37/03-03AAA 58 Walnut Avenue
Takoma Park Historic District

SUBJECT: Historic Area Work Permit # 324581

HISTORIC PRESERVATION COMMISSION STAFF REPORT

PROPOSAL: Remove door/replace with window; replace asphalt wall shingling; repair roof.

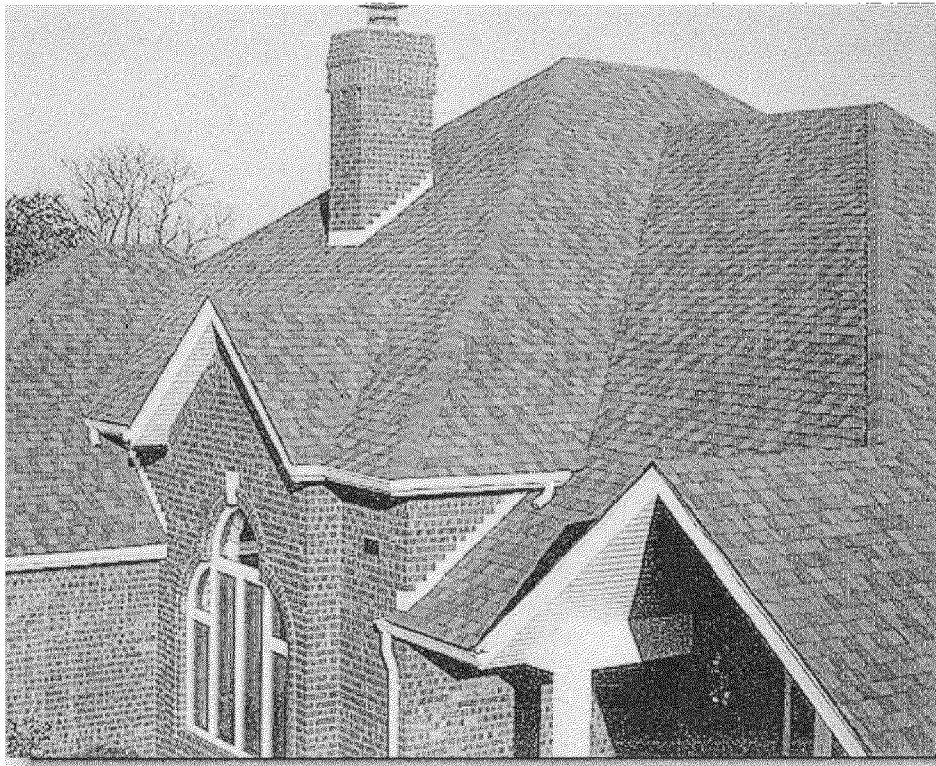
back wall between 2 units
hotel-hotel units
3 1/2' x 70" tall
between 2 windows - 1st floor

View of door to be removed from non-original, mid-20th-century addition, east elevation.

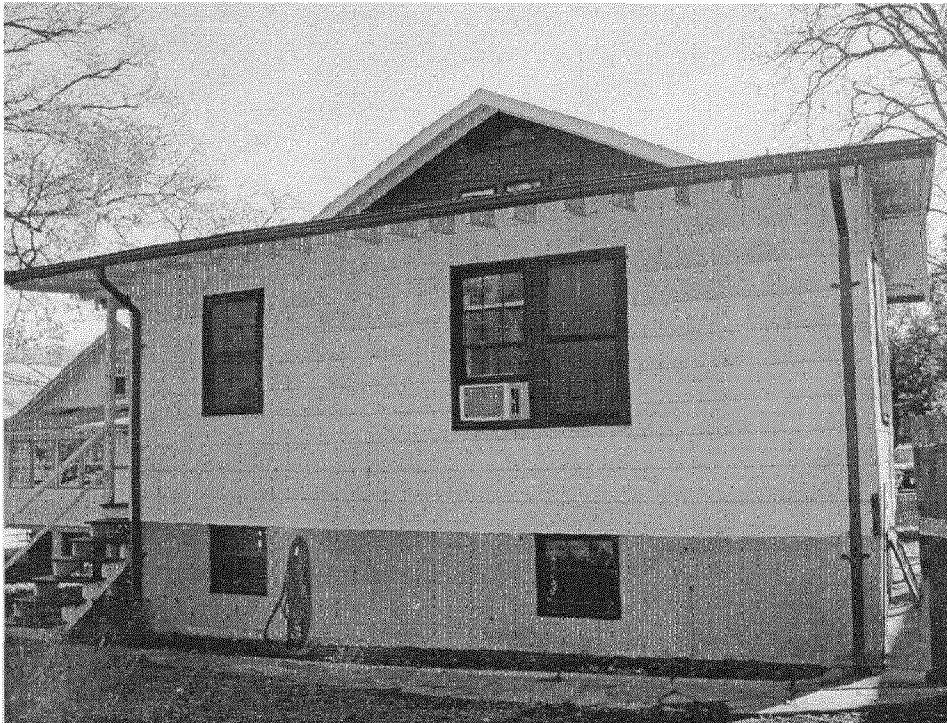
1. Remove a door from the last addition made at the rear to the house (considered a non-contributing addition in the case of this resource) and change the opening to a 20”-wide, 1/1 wood window. The existing adjacent window is currently 6/1, but the proposed drawings show it as a 1/1 window. (The majority of the house’s

openings have been changed to 1/1.) Staff attempted to clarify the discrepancy between the drawings and the existing condition of the 6/1 window, but the applicant was unavailable at the time the staff report needed to be completed. The change from a door to a window is being sought to gain kitchen counter space. The wall area will be repaired to match the existing condition with asbestos-like material.

1. Staff will work with the owner to clarify whether the small window in the non-original, rear, mid-20th-century addition is being changed to a 1/1 or will remain a 6/1 and that staff may approve any minor decorative shingling, should it be deemed appropriate.
